Modification Recommended Service Note

P9377B Keysight Streamline Vector Network Analyzer

Potential lifted front panel overlay

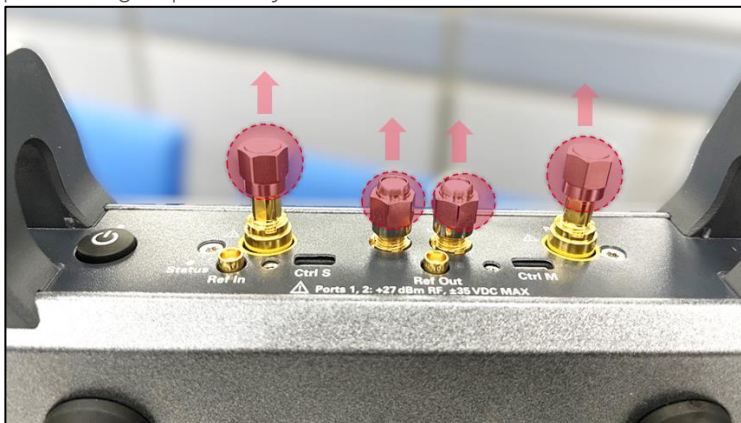
Keysight streamline series vector network analyzer (VNA) of serial number range identified in service note cover page might potentially exhibit the following lifted front panel overlay symptom.

Apart from cosmetic imperfections, the lifted front overlay could have led to non-fully attached *Ctrl S* micro-HDMI cable connector in multi-VNAs setup configuration.

-> Apply this service note only if end users' VNA is exhibiting the following symptom.

Procedure to replace the front panel overlay.

1. Remove the front handles. Detach the 50-ohm termination (LO-In, LO-Out, Port 1 & Port 2) or protecting caps if they are attached to the VNA.

2. Pry open the existing front panel overlay and remove it from front panel.
3. Clean the metal surface thoroughly and ensure it is free of adhesive residue.
4. Affix the new self-adhesive front panel overlay onto the metal surface.
5. Reinstall (reuse) the 50-ohm terminations and port protecting caps accordingly.

6. Reinstall (reuse) the front handles.
